TOPIC 5 – WATER MANAGEMENT

WATER MANAGEMENT – OPERATIONS

WATER MANAGEMENT – N11 DISCHARGE AND DISCHARGE LINE - ENR–38, ENR-39

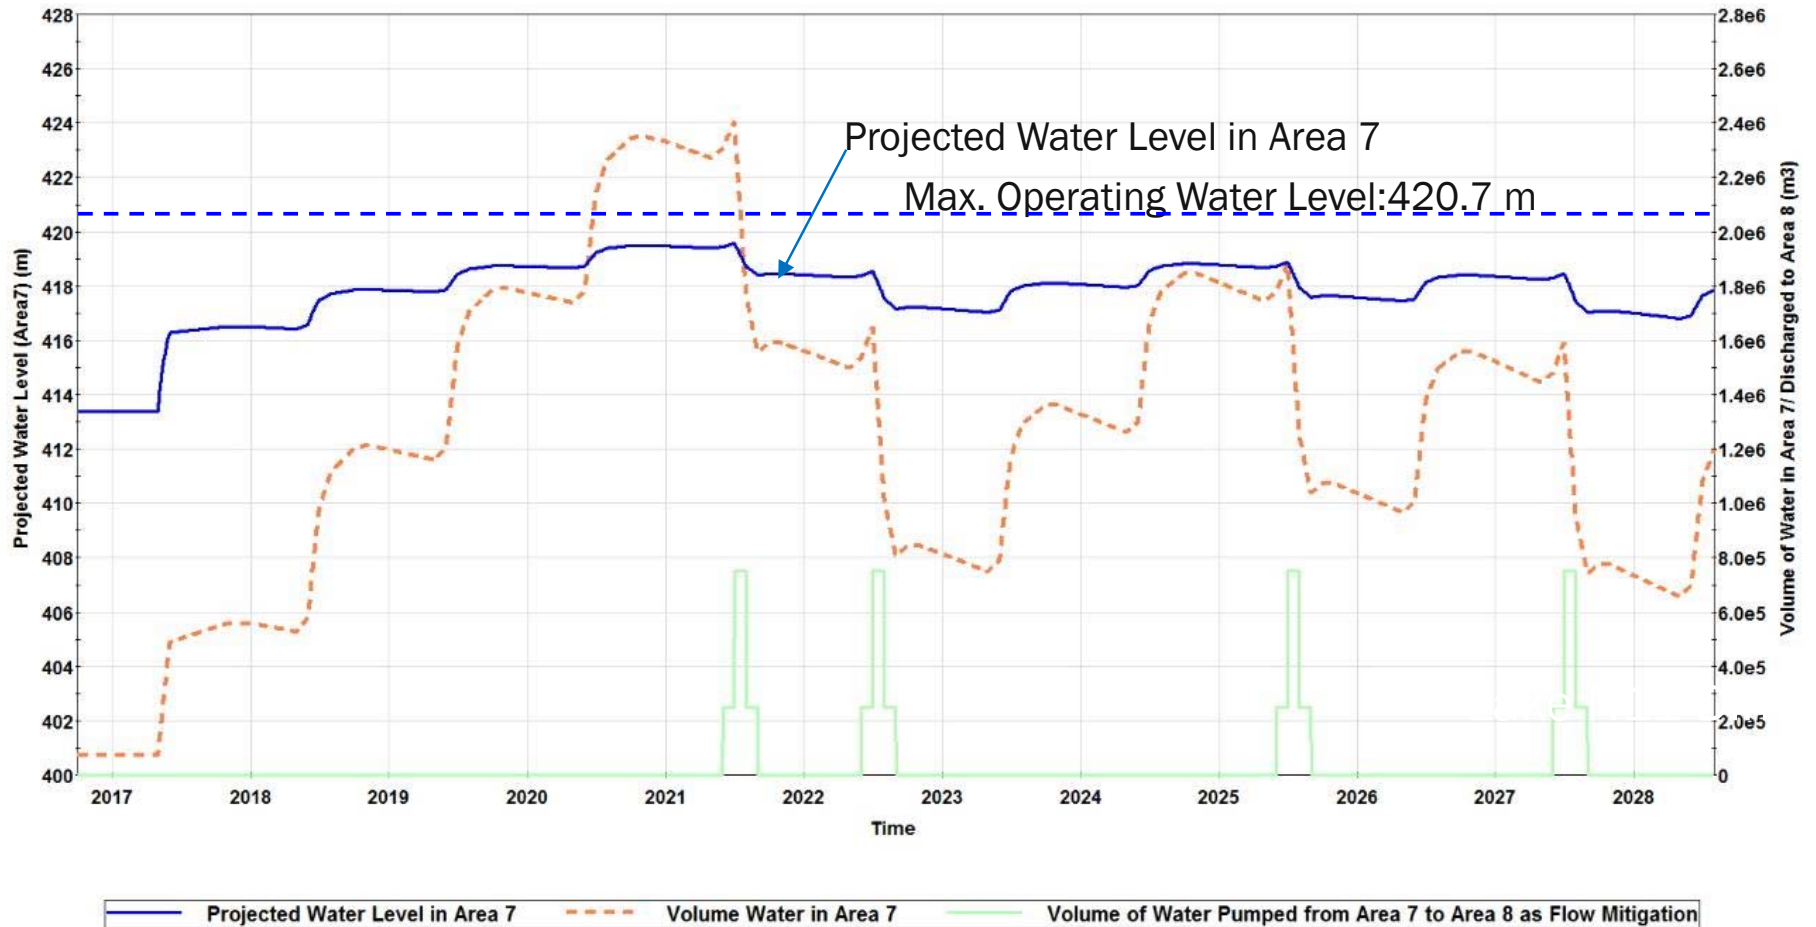
- The anniversary date of the licence is September 24th.
- Discharge is limited to the period between the end of downstream flow mitigation (September 1) to the anniversary date of the licence (September 24). This is an insufficient period of time to discharge the full annual allotment of 3.45 Mm³. Discharge for the following year has to start Sept 25th. Sampling and testing must be done prior to the following year discharge. Two weeks turn around time.

- If the water quality does not meet EQC within the calendar year of 2018 no discharge is allowed. With the spring inflows of freshet in 2019 the water quality could be sufficient for discharge. The entire 3.45 Mm³ would need to be discharged from Sept.1 to Sept. 23, 2019 in order to remain within the terms of the licence and the interpretation of ENR that the water discharge volume is tracked on licence year rather than calendar year.

- It is requested that an annual allotment be allowed to carry over into the subsequent anniversary year of the licence so the discharge could proceed through the fall (over the anniversary date). Alternatively, the calendar year could be used as the water discharge year, consistent with all other aspects of the water licence.
